24 April 2017

**\* IMMEDIATE ATTENTION REQUIRED \***

This notice is to inform AKD owners about a bug in the **Backup FPGA firmware**.

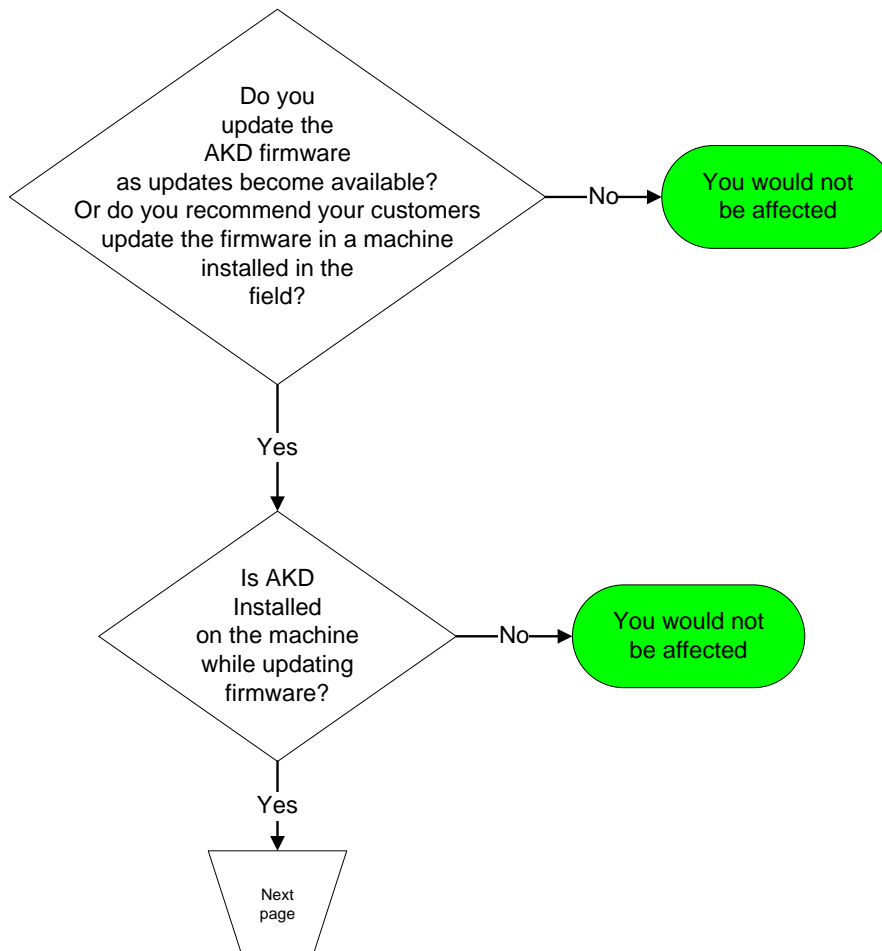
***Is my AKD affected by the bug?*****The following model numbers are affected by the bug:**

- AKD-P; AKD-B; AKD-T; AKD-M
  - KC1-B; KC1-M
- ✓ NOT affected are models beginning with AKD-N, AKD-C

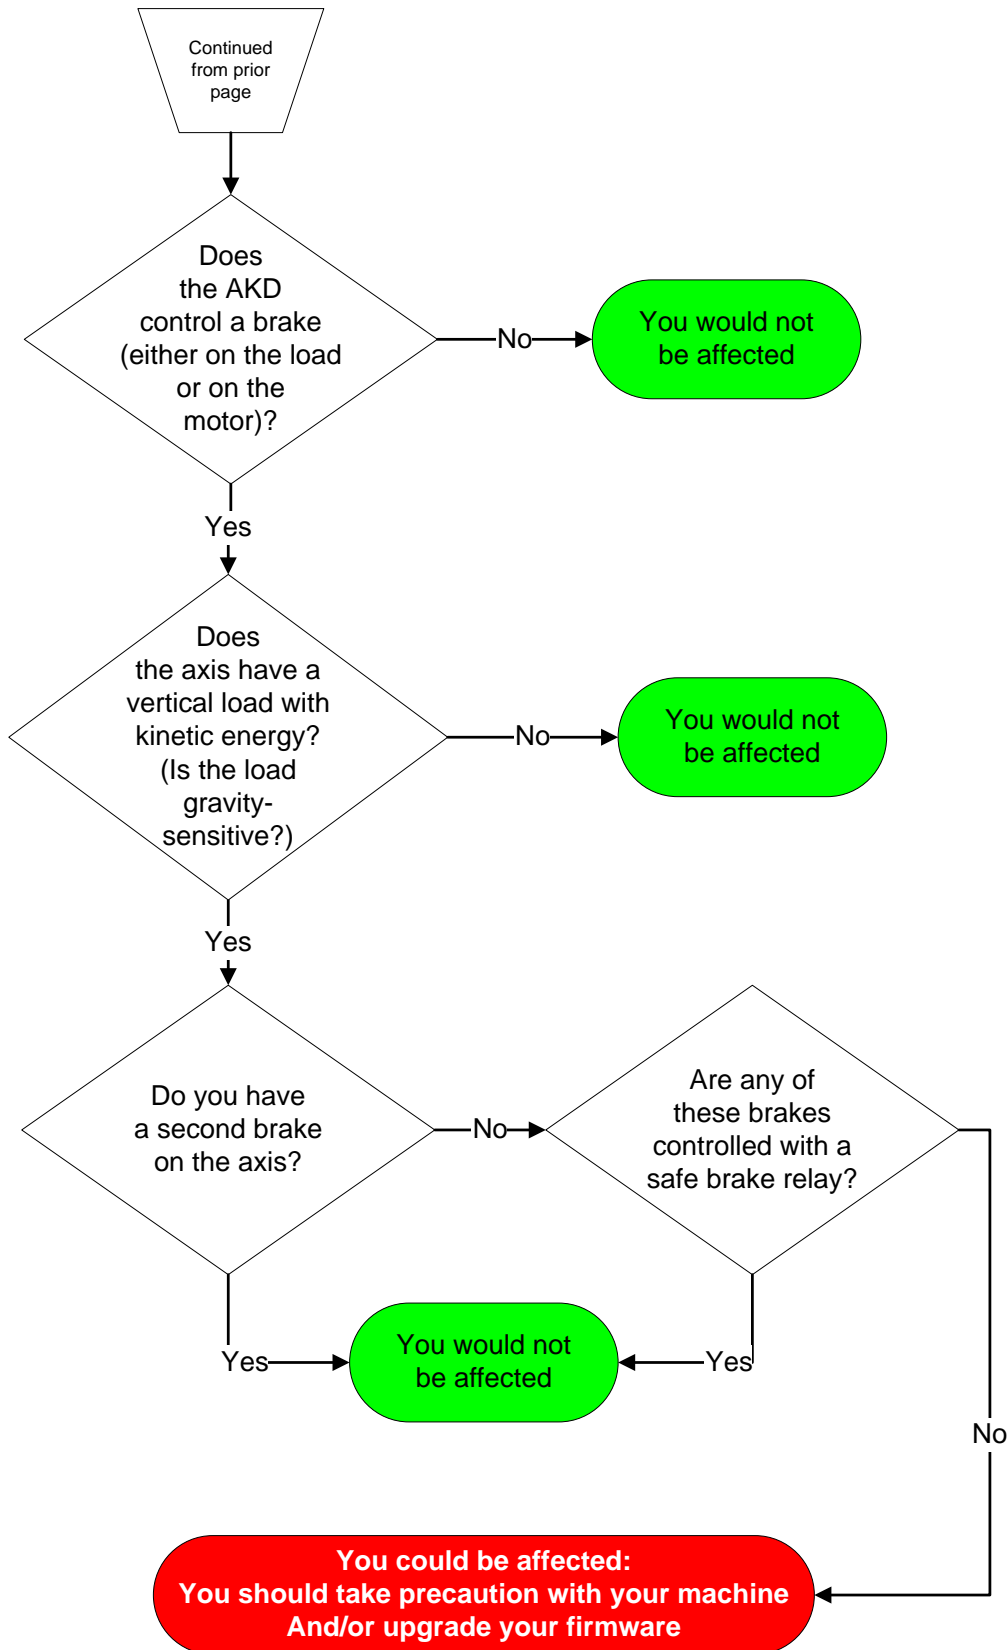
***Is my application affected by the bug?***

If you are using the affected AKDs listed above, your *application* may or may not be affected by this bug. Please follow this flowchart to check if this bug affects your application:

If your application is affected, there are several ways to mitigate risk *without* upgrading your firmware. Each countermeasure alone should eliminate the risk:

1. ***Secure the load or move to a safe position before updating the standard AKD firmware.***  
By securing the load or moving to a safe position, disengaging the brake after a failed firmware update attempt will have no effect. This is actually required by regulatory agencies, so you are likely doing this.

2. ***Unplug the motor when updating the standard AKD firmware.***  
By unplugging the motor from the AKD the brake is also disconnected. Hence it will always stay engaged

**(Remember to remove power to the AKD before disconnecting the motor cables!)**
3. ***Update the Backup FPGA firmware.***  
*We recommend that you update the Backup FPGA firmware if you cannot apply either of the above-recommended countermeasures.*  
*Please visit the [Kollmorgen Developers Network \(KDN\)](#) or specific update instructions.*  
KDN provides downloadable files, along with directions on how to update to Backup FPGA firmware FPB0xx\_0602\_00\_01.
